### Item 3.10 BART SILICON VALLEY PHASE II EXTENSION

Please direct staff to review the attached revised tunneling strategy which uses the integrated BART/LRT DISC box to transition from twin bores to a 1.5-mile 56-foot diameter tunnel for the Downtown section (between Diridon and 13th Street) and report back to Council with a recommendation.

## Background to Revised Tunneling Strategy (Concept #3)

(slide 9)

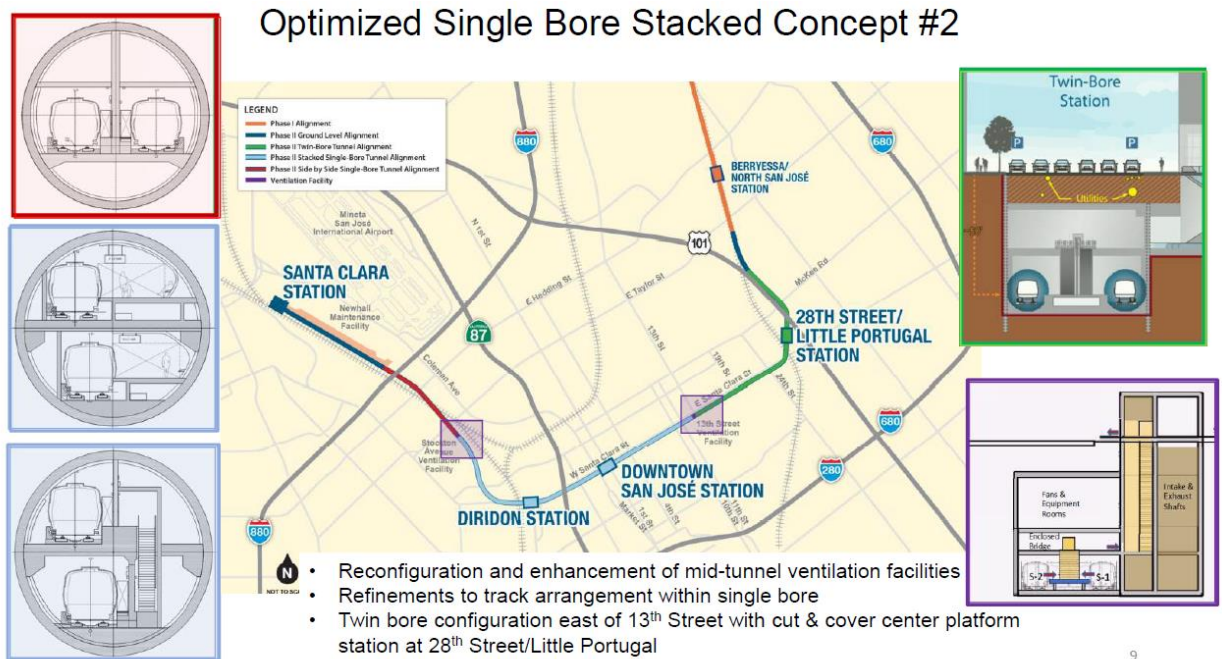
Concept #3 builds on Concept #2 by:

- Additionally transitioning to **twin bores between Diridon and the Newhall Portal**
- **Increasing the bore of the Diridon to 13<sup>th</sup> Street section from 48 feet to 56 feet**
- **Extending the side-by-side tracks section to the entire 5 miles of tunneling**

## Diridon Integrated Station Box

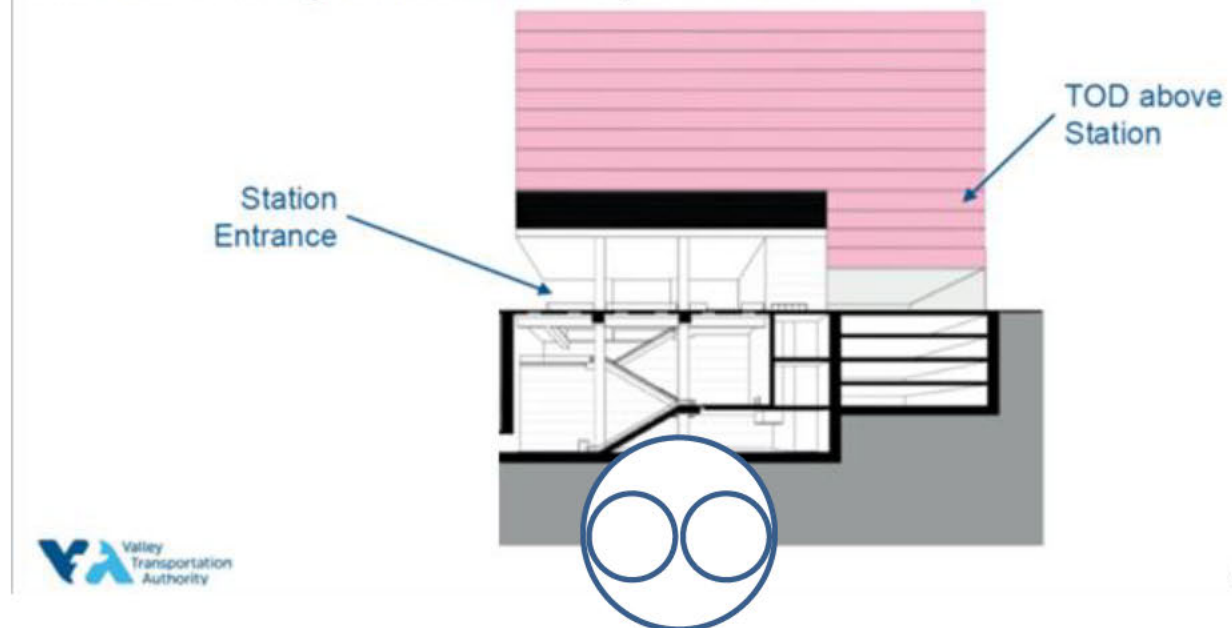
Transition from twin 22-foot bores to a 56-foot single bore “For twin bored tunnels the spacing of the two bores is assumed to be 0.5 times the TBM or starter chamber diameter to the inside face of the portal cutting, with one tunnel diameter between the bores. **This may be reduced if required, particularly for TBM reception.** (Arup HS2 2009)

## Tunnel Section 2: Diridon to 13<sup>th</sup> Street (1.5 miles)

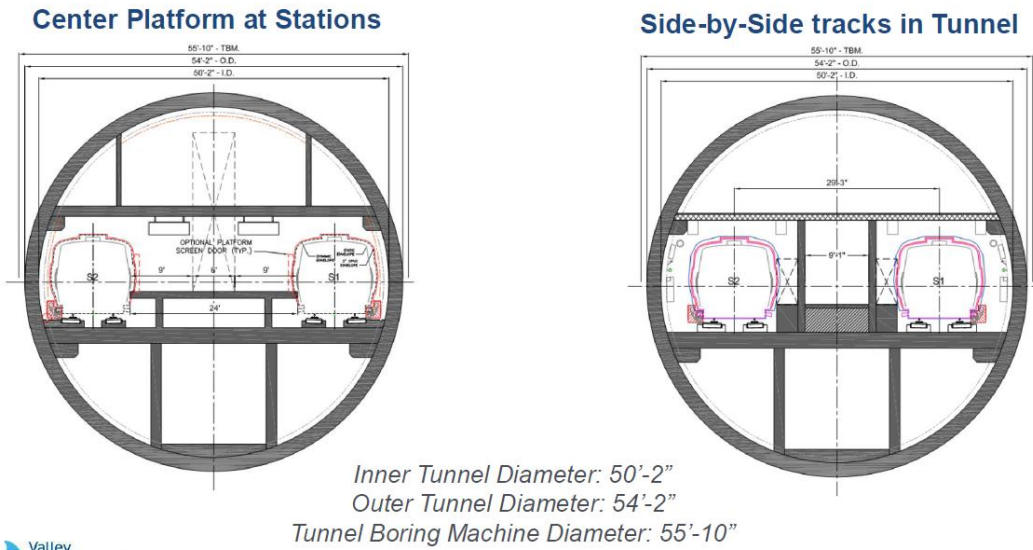
This section includes two identical stations: Downtown and the new 13<sup>th</sup> Street station

## Eliminate potential impacts on single-bore tunnel superstructure integrity

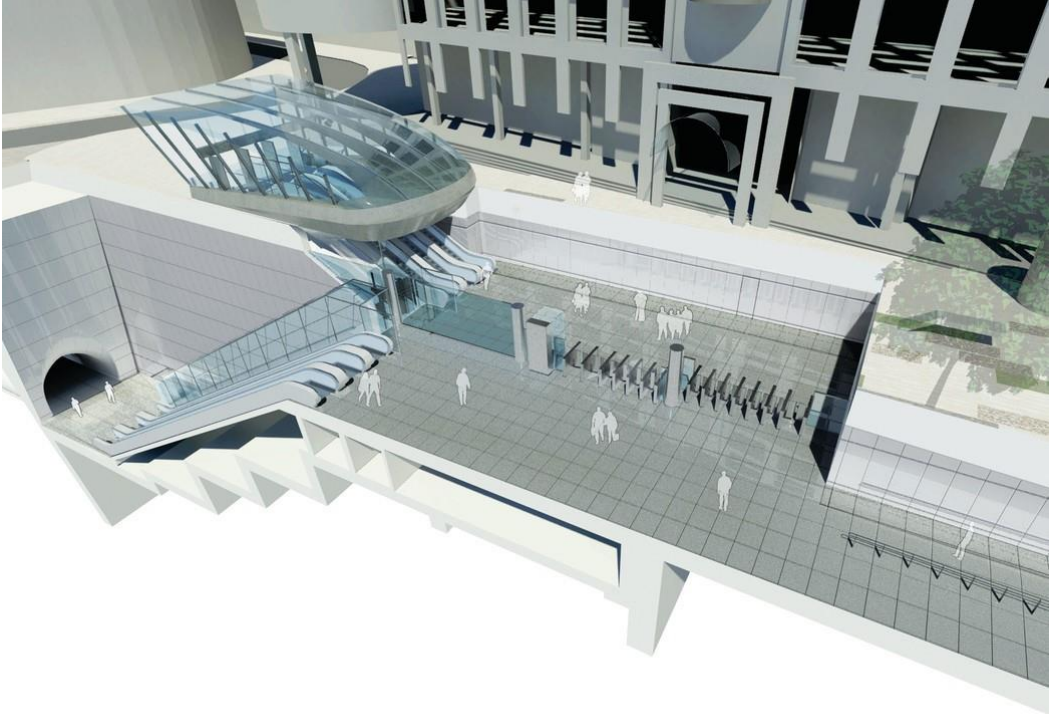
View of the Downtown concourse showing connections to entrances south (left) and north (right) of Santa Clara Street. **Please note that the concourse** can be located anywhere within the tunnel crown and **can exceed the length of the platforms by hundreds of feet if necessary** (example: between Market and 4<sup>th</sup> Street)

## 13<sup>th</sup> Street Station

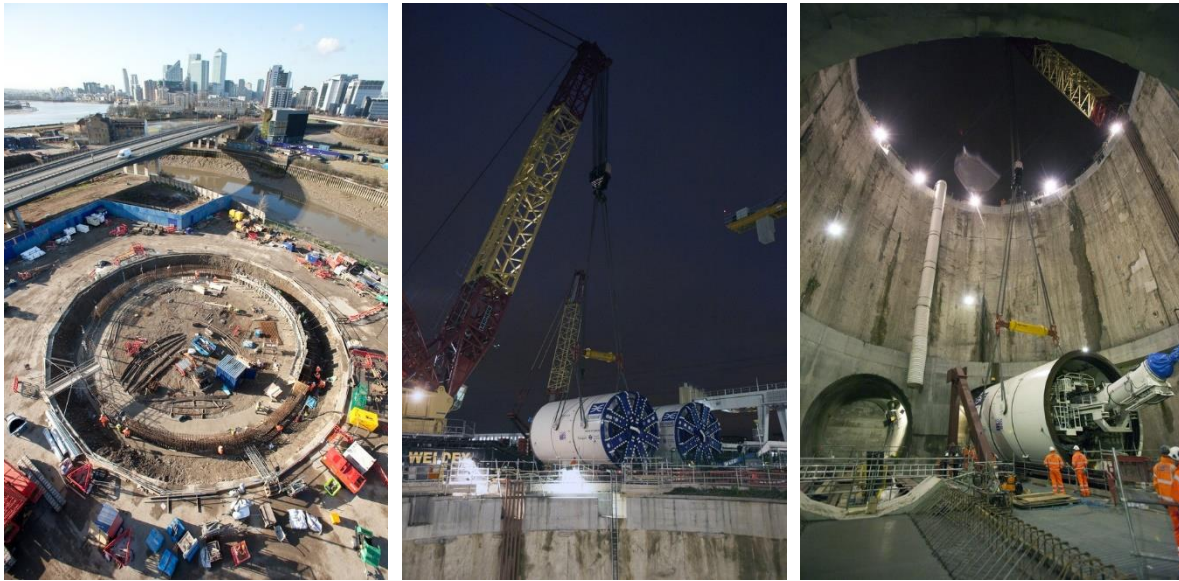
The 13<sup>th</sup> Street station will be identical to the Downtown station. The only impact on East Santa Clara will be a temporary shaft designed to enable the transition between the 56-foot TBM and the twin 22-foot TBMs when they arrive from the 28<sup>th</sup> Street station. The location of the shaft will delimit the eastern end of the 13<sup>th</sup> Street station and will be integrated into the station's eastern headhouse after tunneling completes.

Additional 13<sup>th</sup> Street station entrances will be integrated into adjacent P3 opportunities as and when they materialize

## Tunnel Section 3: 13<sup>th</sup> Street shaft to Las Plumas portal (2 miles)

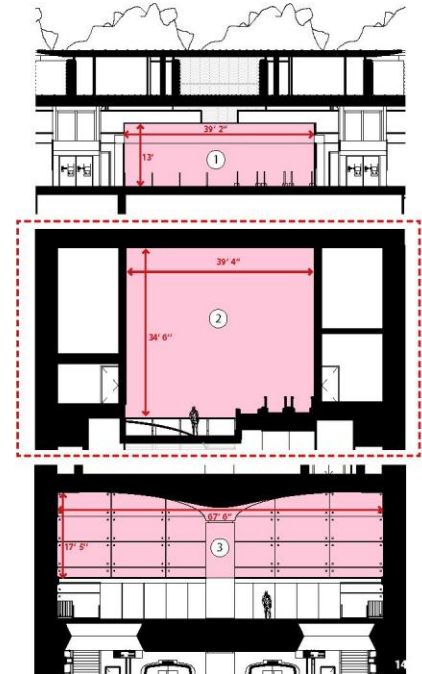
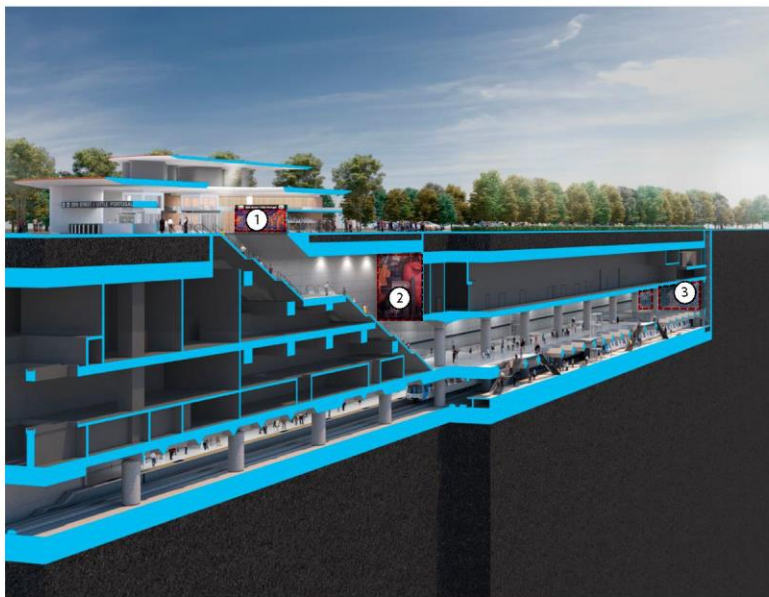
- Twin 22-foot bores with cross-passages every 300 feet (BART Facilities Standards)
- Evacuation/rescue through adjacent (“non-incident”) tunnel (Arup 2009)
- Smaller tunnel diameters
  - o **Lower risks tunneling under Coyote Creek and Highway 101**
  - o **Reduce 28<sup>th</sup> Street station depth by approximately 30 feet**
  - o Preserve 400 feet of **brand new** Berryessa tail tracks
